## FOUNDATION INVESTIGATION REPORT

Sec. Hwy. #523 Line 'A' and Moore Ck.  
District of Nipissing, Twp. of Lyell,  
District #10 (Bancroft)

W.J. 65-F-22      --      W.P. 256-62

Moore Creek Bridge - Sec. Hwy. 523, District No. 10,  
W.P. 256-62 -- Site No. 43 s 155 -- W.J. 65-F-22.

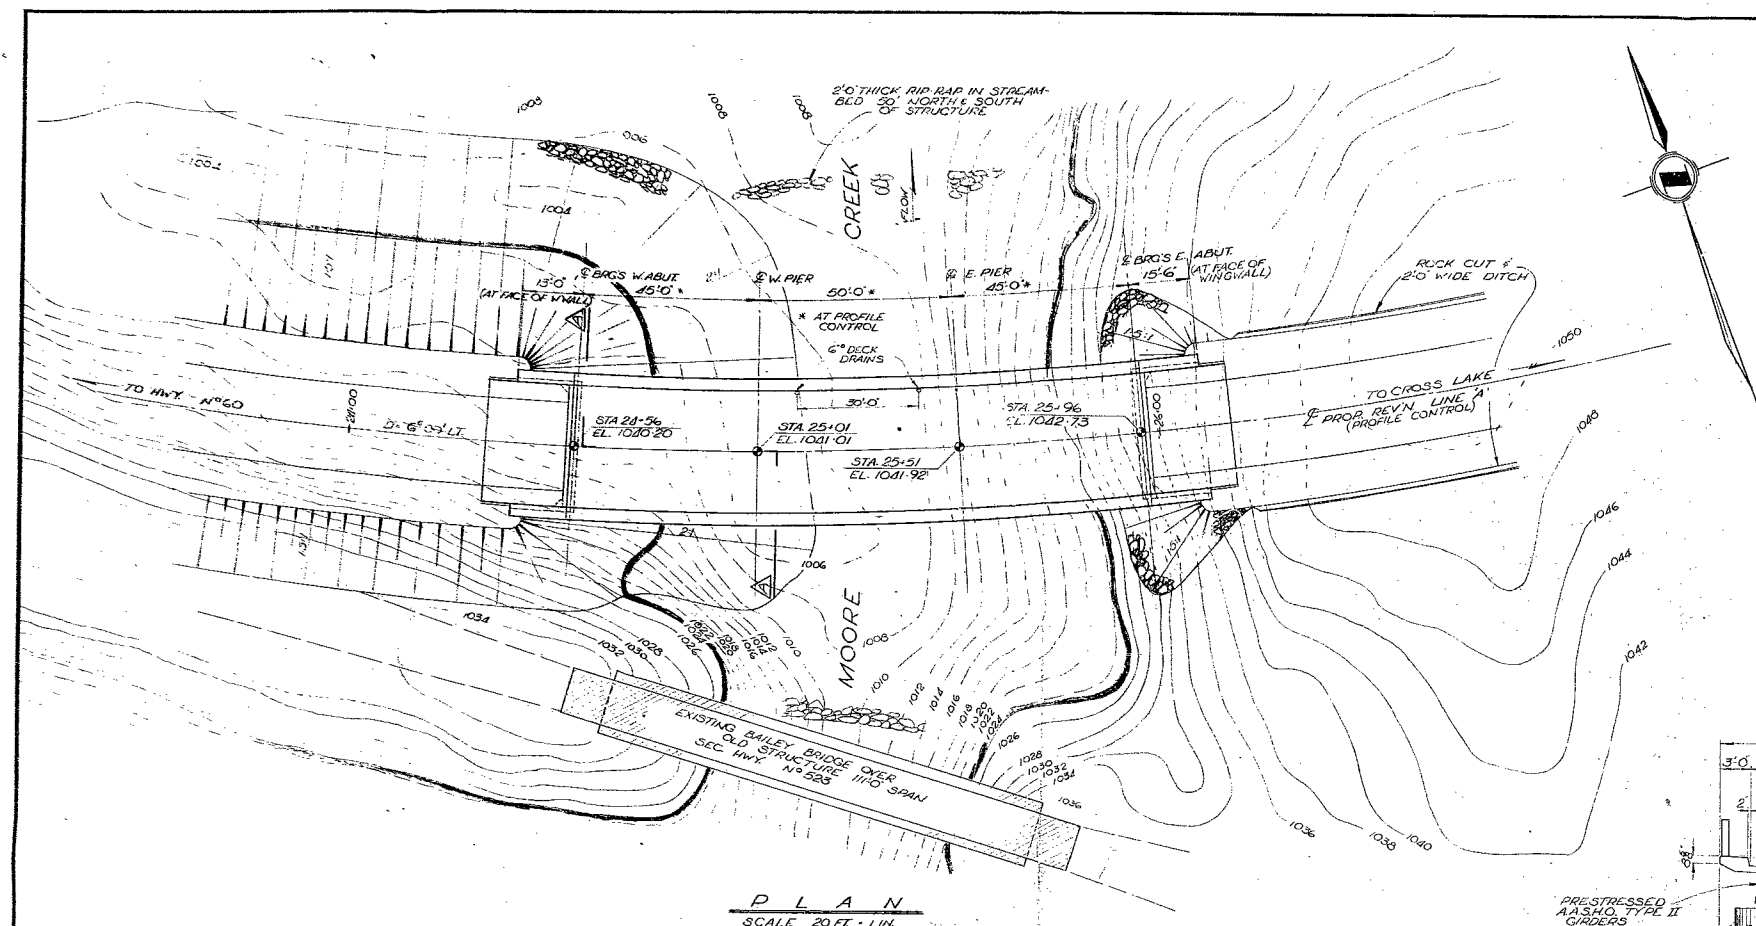
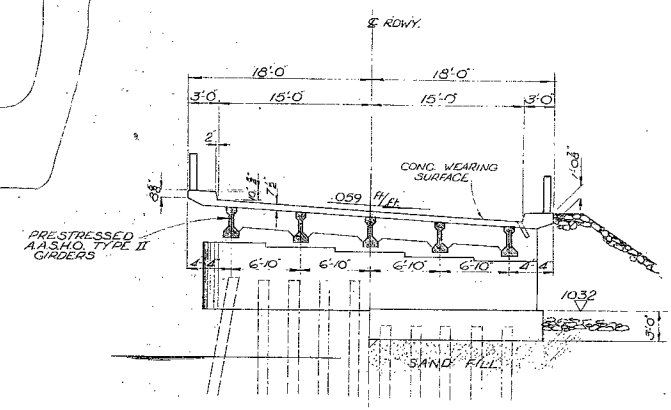
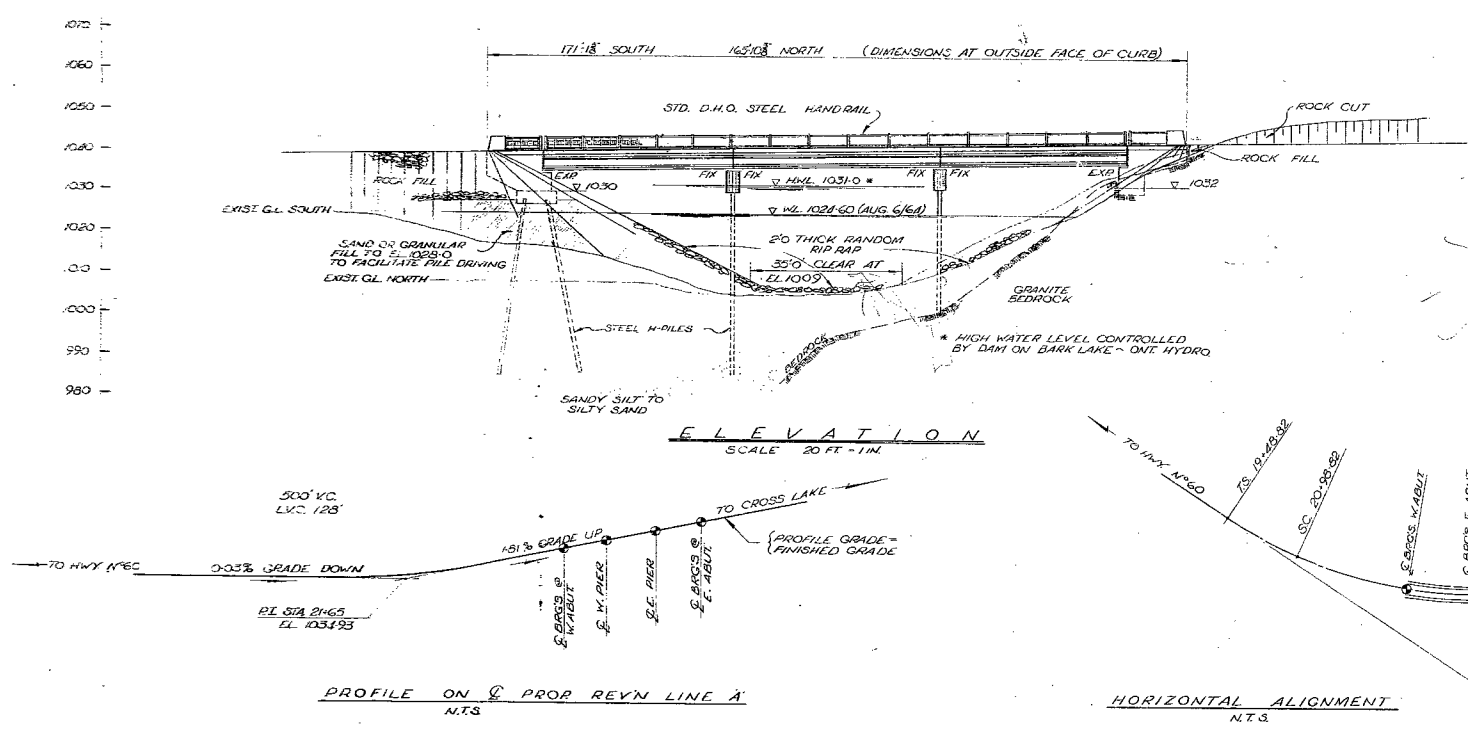
With reference to your verbal enquiry, "Is the penetration of piles at the East pier sufficient?" - we would like to submit the following comments and recommendations for your consideration:

At the proposed East pier location, the overburden is only about 7 ft. thick, consisting of sandy silt to silty sand, both very scour-susceptible materials.

We have examined Drawing No. D-5731-P1. The only comment we have to make is as follows:

We wish to be definitely assured that the penetration indicated for the piles of the east pier is sufficient - this may require further investigation.

Because of the dipping bedrock surface, Oslo points are recommended for the H-piles. The use of these points should enable the keying of the piles into the rock for a distance of approximately 4 inches.

Being advised that the flow of water of the Moore Creek is very slow, we felt that with some additional rip-rapping, the suggested procedure would be satisfactory. However, when the whole problem was re-appraised and reconsidered, we now feel that it would be advisable to use another approach that would constitute a more definite solution.

It is recommended that the piles be keyed into the bedrock 3 - 4 feet. This can be achieved by churn drilling holes in bedrock into which piles are lowered and the holes grouted. We would recommend this procedure at the East pier location only, because adequate overburden exists in other places. However, because of the sloping bedrock surface, Oslo points should be used at the West pier location.
